A Review of Proposed Upgrades to the High Flux Isotope Reactor and Potential Impacts to Reactor Vessel Integrity

F. A. Simonen

May 2001

**A Review of Proposed Upgrades to the
High Flux Isotope Reactor and
Potential Impacts to Reactor Vessel Integrity**

Figure 1. Flaw Frequencies as Estimated for HFIR Vessel Compared to Data From Recent NRC Research Studies at PNNL.

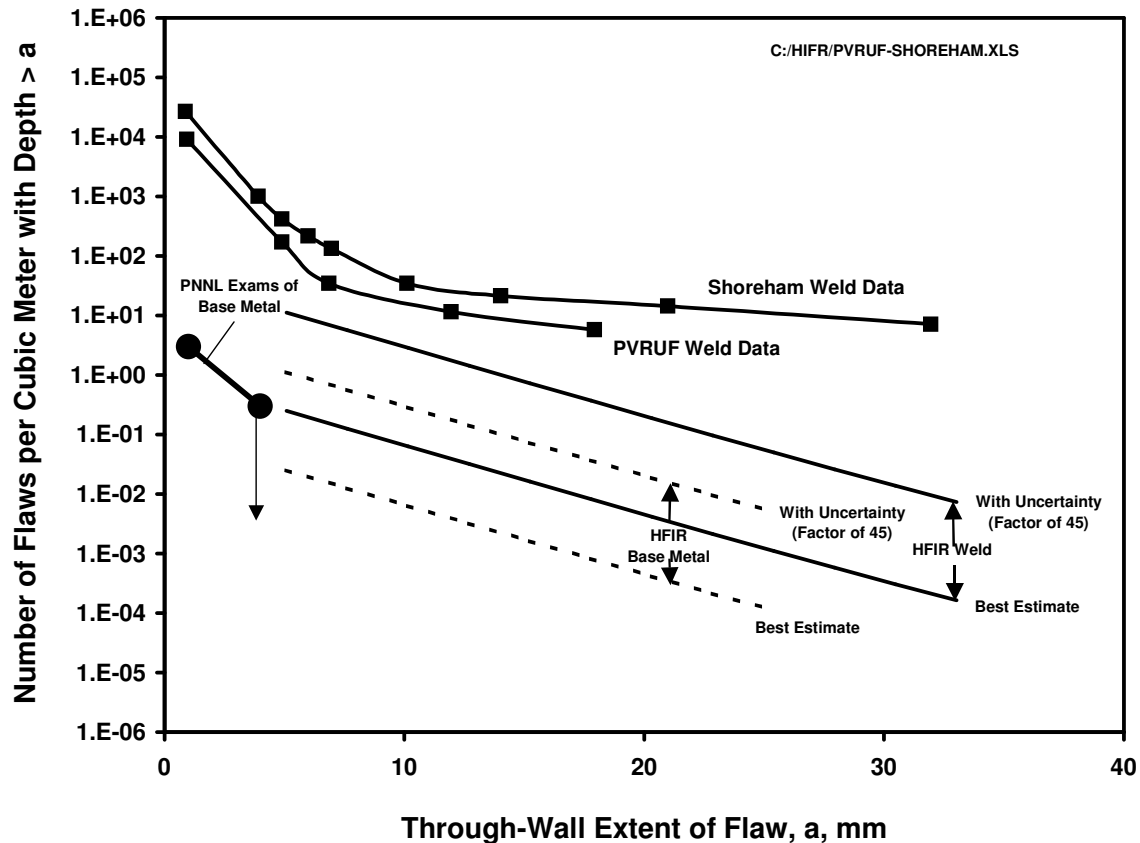
Figure 1 compares the ORNL estimates (based on the current NRC-approved methodology) for the number and sizes of flaws in the HFIR vessel with the number and sizes of observed flaws that have been found by PNNL by examinations of vessel welds and plate material. The studies by PNNL were part of NRC-funded research (Doctor et al. 1999) that made use of both nondestructive and destructive examination methods.

Data from the PVRUF and Shoreham vessels show that flaw densities in weld metal are much greater than the 1.0 flaw per cubic meter (best estimate) value of the current NRC methodology. Even with the factor of 45 to account for the uncertainty in the flaw density, the values used for the HFIR evaluation are still unconservative. On the other hand, the PNNL vessel examinations show that weld flaws are distributed uniformly through the thickness of the vessel wall, rather than at the inner surface of the vessel (worst-case location). The effect of flaw location is shown here to more than offset the underestimation of flaw density.

The observed flaw density for base metal is about 1.0 flaw per cubic meter compared to the 0.1 flaws per cubic meter value of the current NRC methodology. The factor of 45 used by ORNL for HFIR calculations is more than adequate to bound the data from the PNNL studies. The PNNL studies for base metal have focused exclusively on flaws with radial (through-wall) extent rather than benign flaws that

are parallel to the vessel surface. In the examinations to date, about one cubic meter of plate material has been examined. Only one flaw (about 1-2 mm in size) has been detected (shown as a data point on Figure 1). The other data point conservatively assumes that examinations of a greater volume of material would detect about 0.3 flaws per cubic meter with a depth of 4 mm. Flaws of 4 mm depth can be detected by PNNL's ultrasonic method with a high level of reliability.

Figure 2. Calculated Failure Probabilities for Axial Weld of HFIR Vessel Showing Effect of Conservative Assumptions for Flaw Related Inputs.

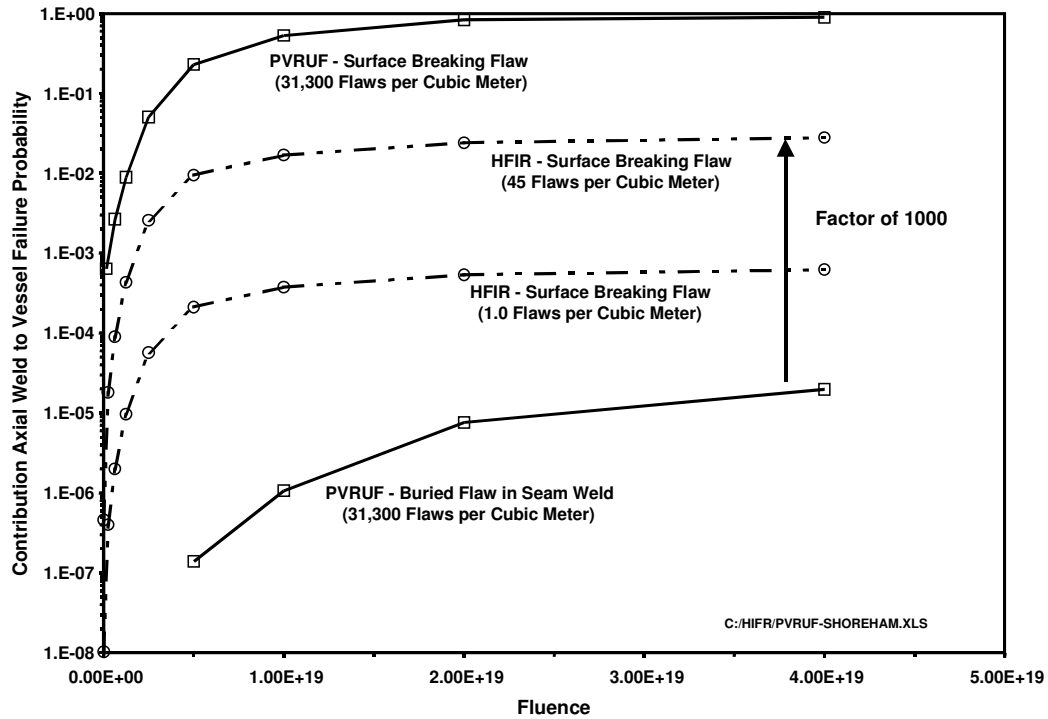
As part of the current review, sensitivity calculations were performed with the VISA-II probabilistic fracture mechanics code (Simonen et al. 1986). Results for axial welds and for the vessel shell (base metal) are shown in Figures 2 and 3, respectively. The two contrasting cases of interest are

- (1) Figure 2 shows that the HFIR evaluations may overestimate the failure probabilities for welds by a factor of 1,000 compared to PNNL predictions made on the basis of the more realistic data for flaw densities and size distributions.
- (2) Figure 3 indicates that the HFIR evaluations may overestimate the failure probabilities for the vessel shell by a factor of 10,000 compared to PNNL predictions made on the basis of the more realistic data for flaw densities and size distributions.

Figure 3. Calculated Failure Probabilities for Vessel Shell of HFIR Vessel Showing Effect of Conservative Assumptions for Flaw Related Inputs.

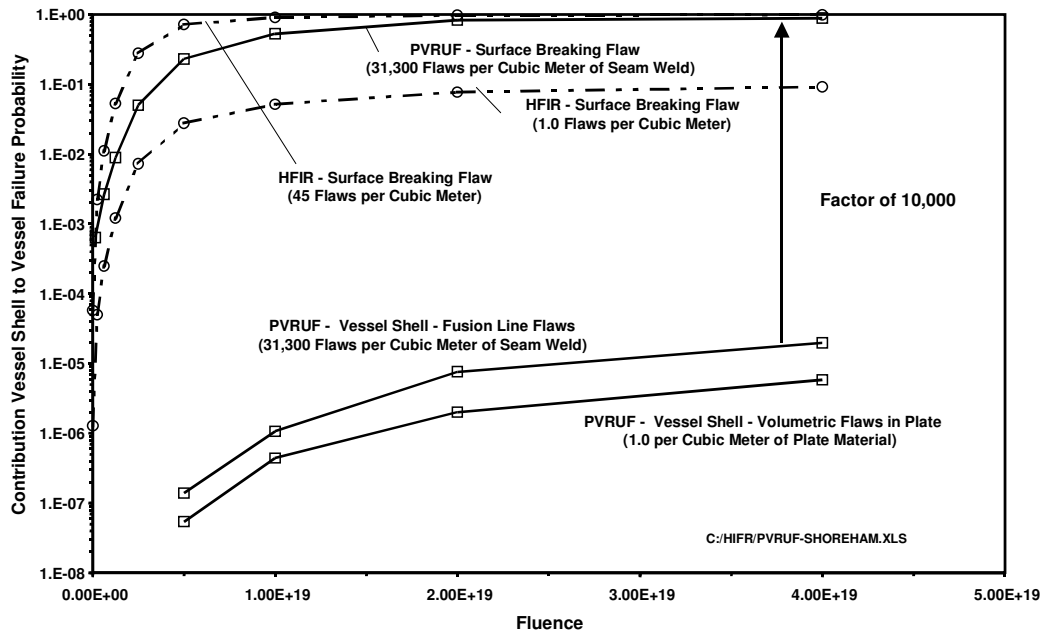
The calculations show that placing the flaws at the inner surface is a very conservative assumption, which by itself more than offsets the uncertainties associated with the ORNL inputs for flaw densities.
